Fisher Information Notice: FIN 2016-03

Subject: Groove Pin Dedication

Items subject to this Fisher Information Notice (FIN) were provided to Tennessee Valley Authority (TVA) Watts Bar Nuclear Plant per TVA Order 702507 (Fisher Order Number 025 - N230331922). Specifically, this FIN applies to a plug/stem assembly that Fisher Controls International LLC (Fisher) supplied to TVA, item number 15A2560X072 (Equipment). In this Equipment, the essential-to-function groove pin was erroneously provided as commercial-grade.

Item 1
Part Identification Sketch

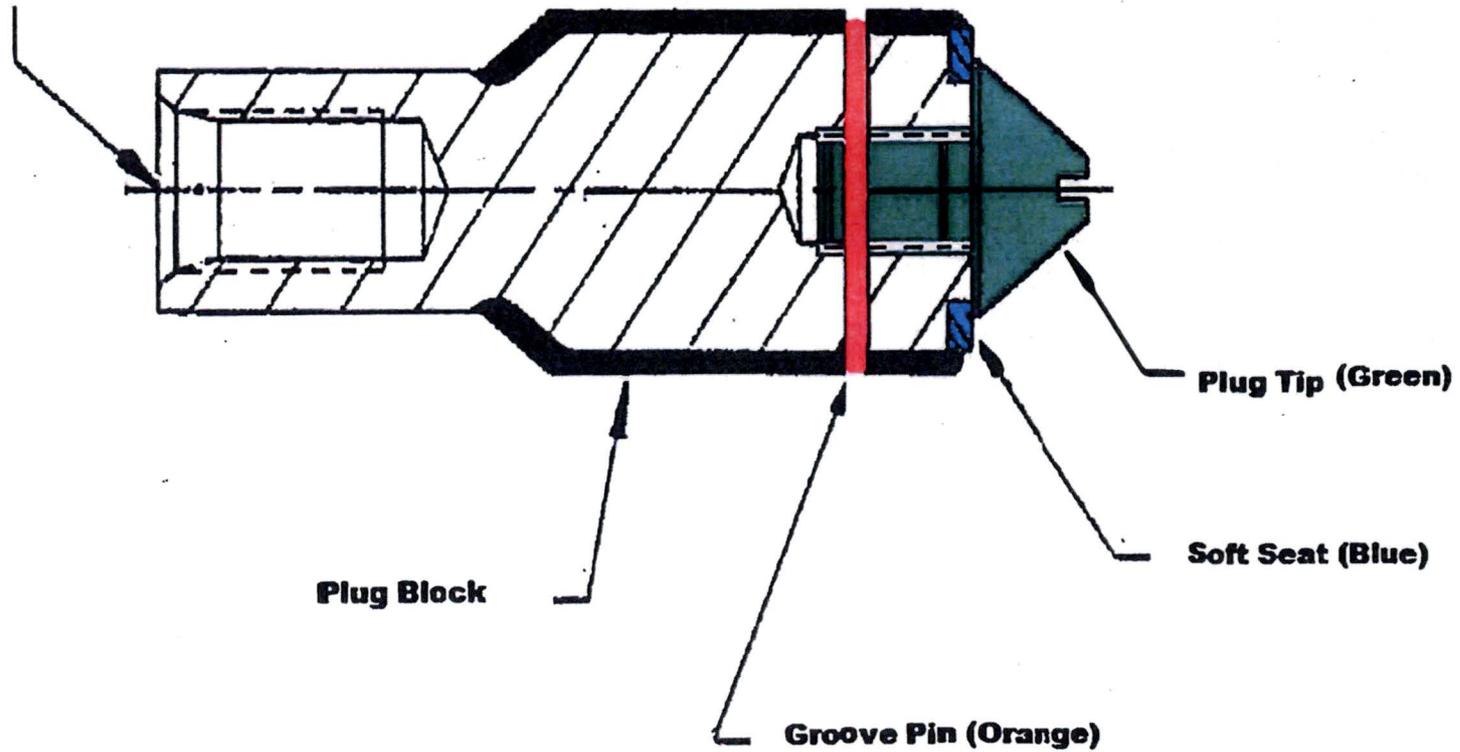
The supplied Equipment in question features a plug tip which is connected to the plug by a simple threaded joint. A groove pin is used to prevent the plug tip from unscrewing from the plug block (please see attached Item 1 for part identification). Because the threaded joint is not self-locking, the groove pin serves as a primary locking device. It is therefore considered essential-to-function and requires dedication per FMP2K27 (Control of Commercial Grade Items to be Dedicated for Use in Nuclear Safety-Related Applications). However, review of the documentation package reveals that the groove pin was not subjected to the requirements of FMP2K27; thus, the part was supplied as a commercial-grade item.

Plug Block: ASME Code Part
Plug Tip: Dedicated Part
Soft Seat: Dedicated Part
Groove Pin: Dedicated Part

Fisher will provide TVA with a properly dedicated groove pin. In addition, a Corrective Action Request (CAR 1796) has been initiated by Fisher to prevent reoccurrence of this issue.
